Intersection ID: 52494	Main Street: WEST_BV	Cross Street: NEW_RENAISSANCE_WY	Location:	NW
ADA ID: 8EA004A362BE	Ramp Type: Perpendicular Diagonal	Initial Pass/Fail: Fail	Overall Compliance: No	Severity Score: 12.5

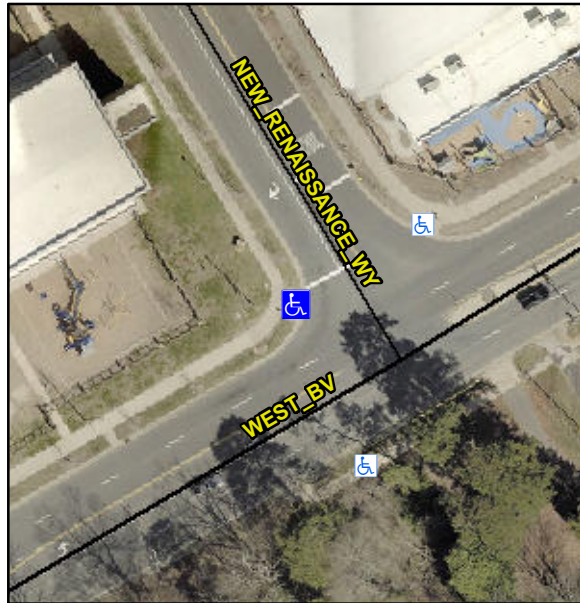
Not Found, R304.5.3

Compliance	Description	Data	Compliance	Description	Data
N/A	Ramp Length (in)	100.0	Yes	Ramp Slope (%)	5.8
Yes	Ramp Width (in)	48.0	No	Ramp XSlope (%)	5.9
N/A	Flare Type LT	N/A	N/A	Flare Type RT	N/A
N/A	Flare Slope LT (%)	N/A	N/A	Flare Slope RT (%)	N/A
N/A	Flare Traversable LT?	N/A	N/A	Flare Traversable RT?	N/A
N/A	Landing Length (in)	N/A	N/A	DWS Provided?	N/A
N/A	Landing Width (in)	N/A	N/A	DWS Contrast?	N/A
N/A	Landing Slope (%)	N/A	N/A	DWS Length (in)	N/A
N/A	Landing X Slope (%)	N/A	N/A	DWS Full Width?	N/A
N/A	Landing Curb? (Y/N)	N/A	N/A	DWS Offset (in)	N/A
N/A	Shared Landing?	N/A			
N/A	Gutter Ponding?	N/A	N/A	Gutter Slope (%)	N/A
N/A	Gutter Lip Ht (in)	N/A	N/A	Gutter X Slope (%)	N/A
N/A	Painted X Walk1?	No	N/A	Painted X Walk2?	No
	X Walk 1 Direction	To S		X Walk 2 Direction	To E
N/A	X Walk 1 Width (in)	N/A	N/A	X Walk 2 Width (in)	N/A
	X Walk 1 Slope (%)	1.1		X Walk 2 Slope (%)	1.9
	X Walk 1 X Slope (%)	2.9		X Walk 2 X Slope (%)	2.1

Remove & Replace Curb Ramp With Two New Directional Ramps or Equivalent.
